ACCEPTING THE LOWEST RESPONSIVE QUALIFIED BID AND AWARDING A CONSTRUCTION CONTRACT IN THE AMOUNT OF $144,002.00 TO ORTIZ GROUP CONTRACTORS, LLC. FOR THE LEE'S CREEK PARK IMPROVEMENTS PROJECT, A 2012-2017 BOND-FUNDED PROJECT, LOCATED IN COUNCIL DISTRICT 7.

ADDENDUM NO. 1

PROJECT NAME: **LEE'S CREEK PARK**

TCI PROJECT NO.: **40-00367**

L 2.1

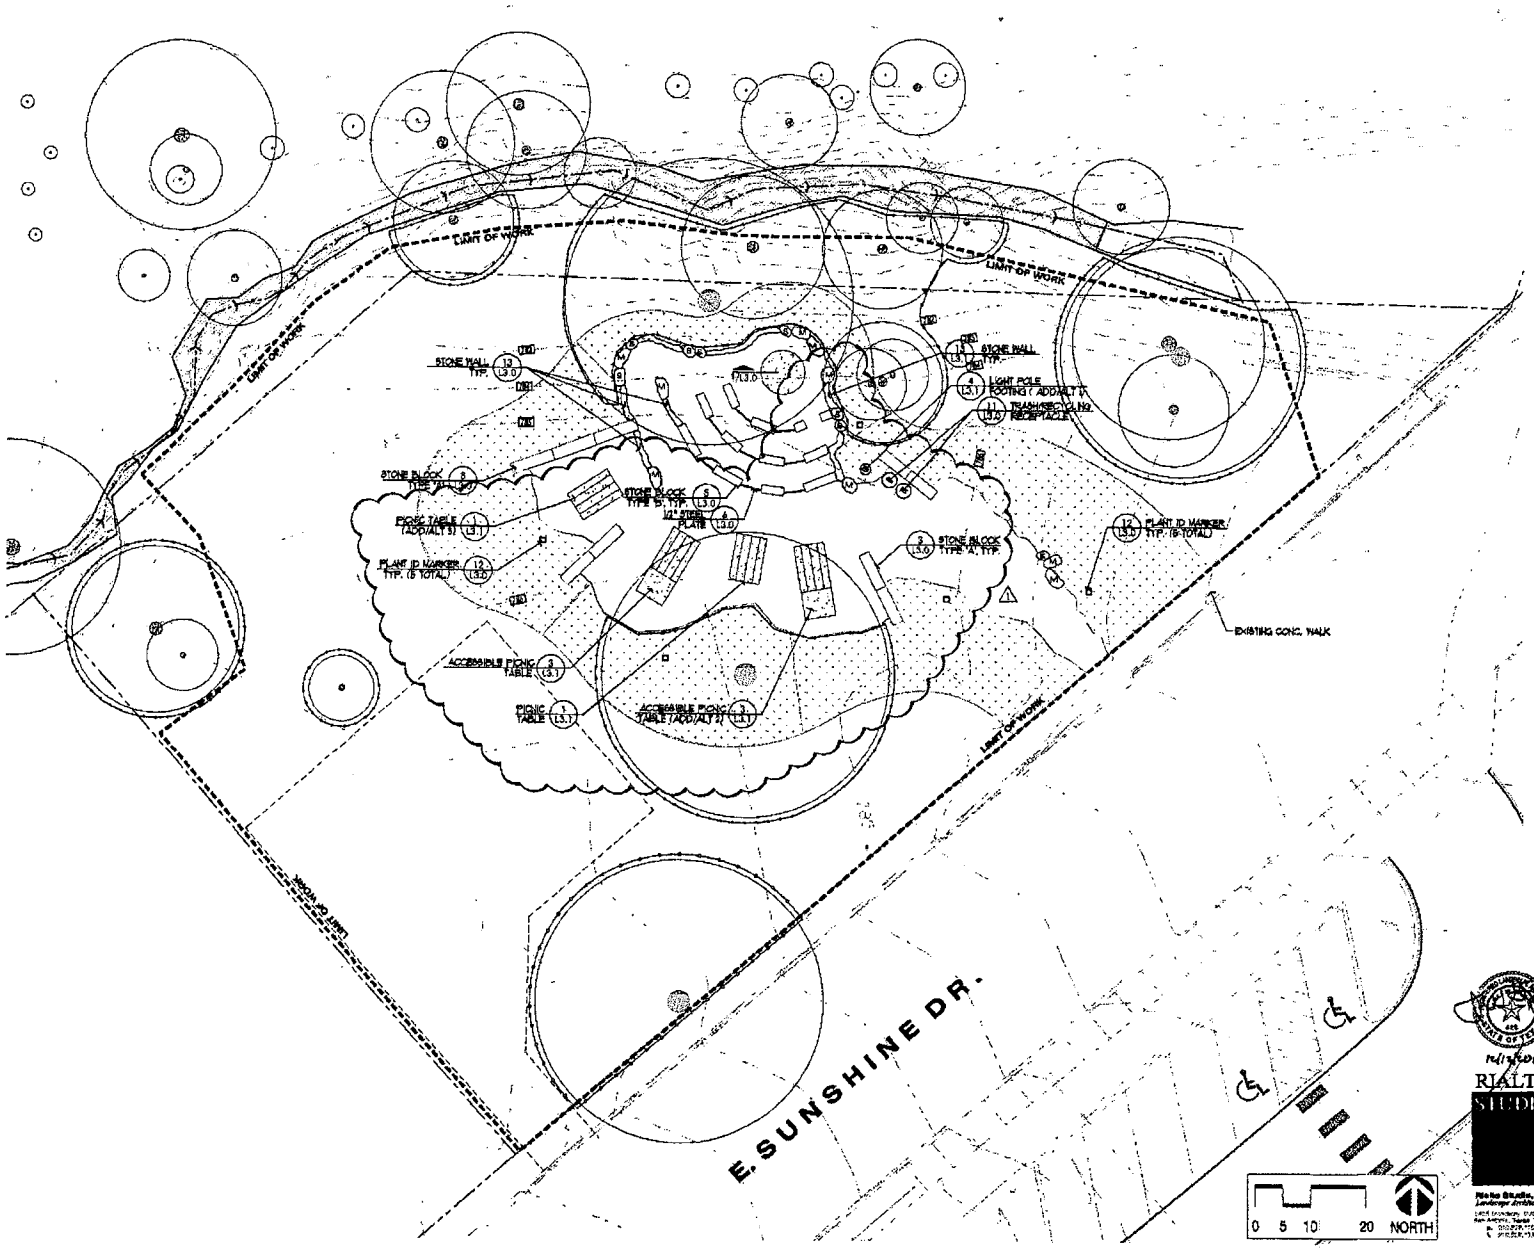
1. QUESTION: "Alternate #1 – Add - Provide and Install Solar Light & Concrete Footing. Please provide specifications for solar lighting, pole and fixture."

RESPONSE: Reference 'Site Furnishings' Specifications Section as noted on sheet L2.1 legend.
2. QUESTION: "Alternate #2 – Add - Provide and Install Standard Stone Picnic Table. Sheet L2.1 – L1/3.1 note two each to be added as Alternate #2. Please clarify."

L 2.4

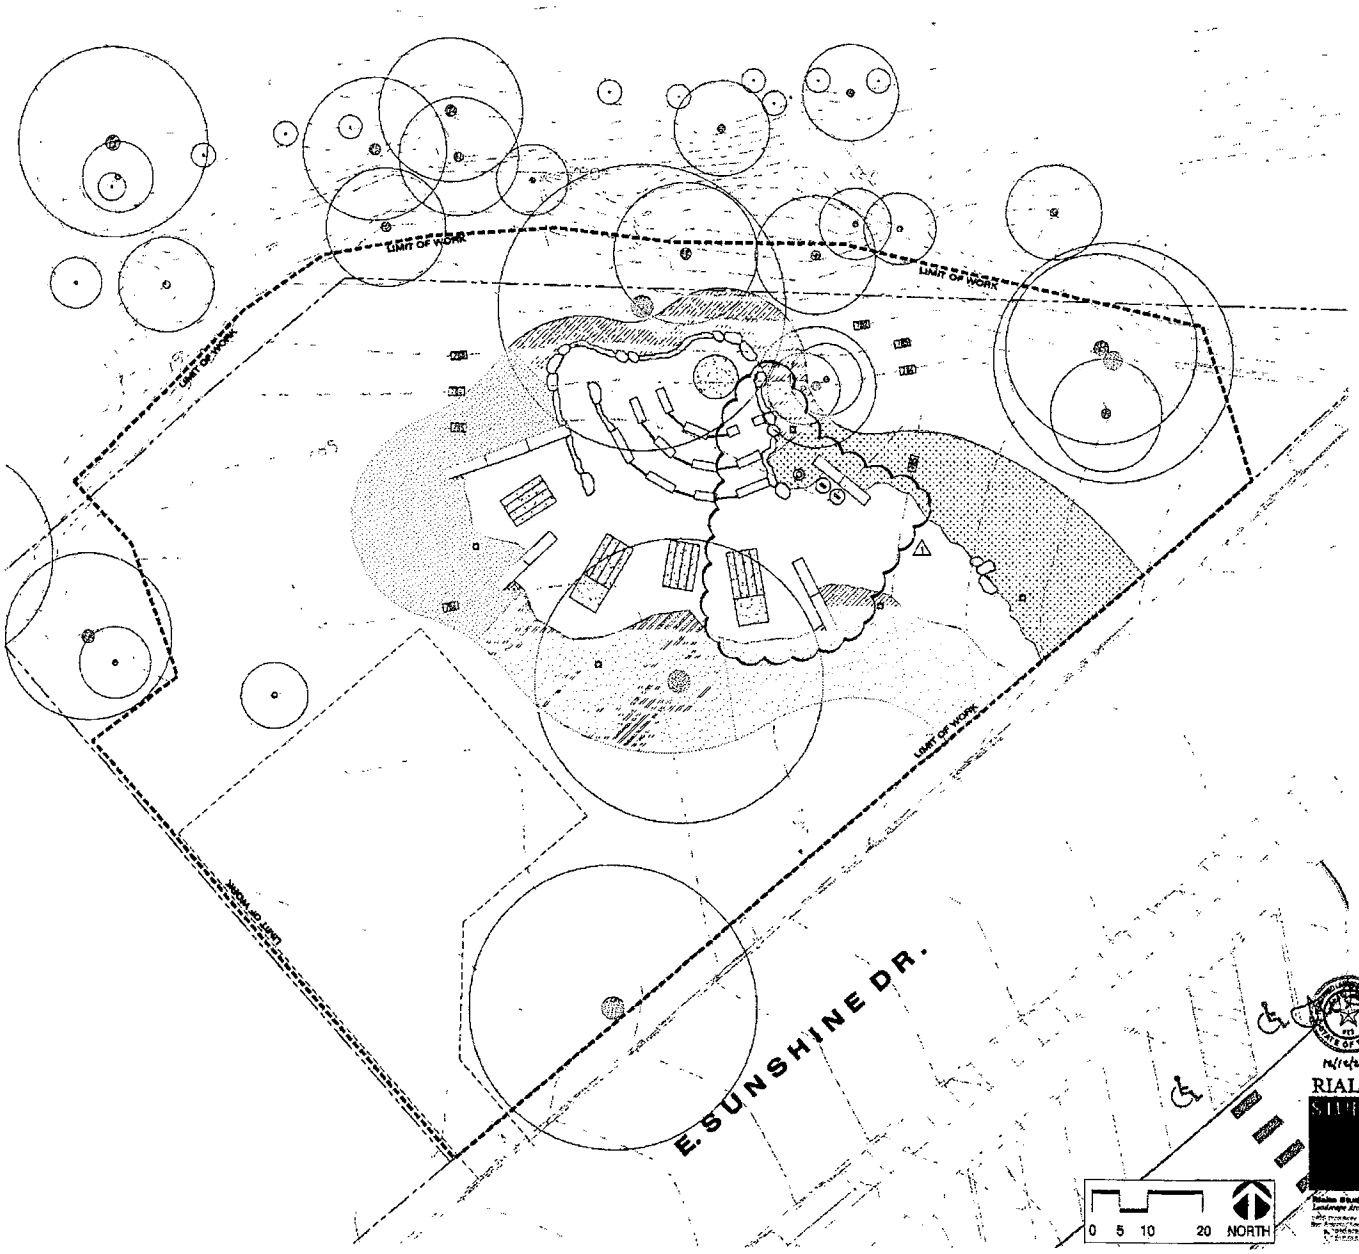
RESPONSE: Addendum #1 revises this Add/Alt.
4. QUESTION: "Sheet L2.4 Wildflower Seeding Plan – Designated areas for each species are shown on plan. Is edging intended to be used for a division barrier between wildflower sections, wildflower & decomposed granite sections, and wildflower and native vegetation areas? Please clarify and provide specified detail of edging if required."

RESPONSE: No edging is intended.
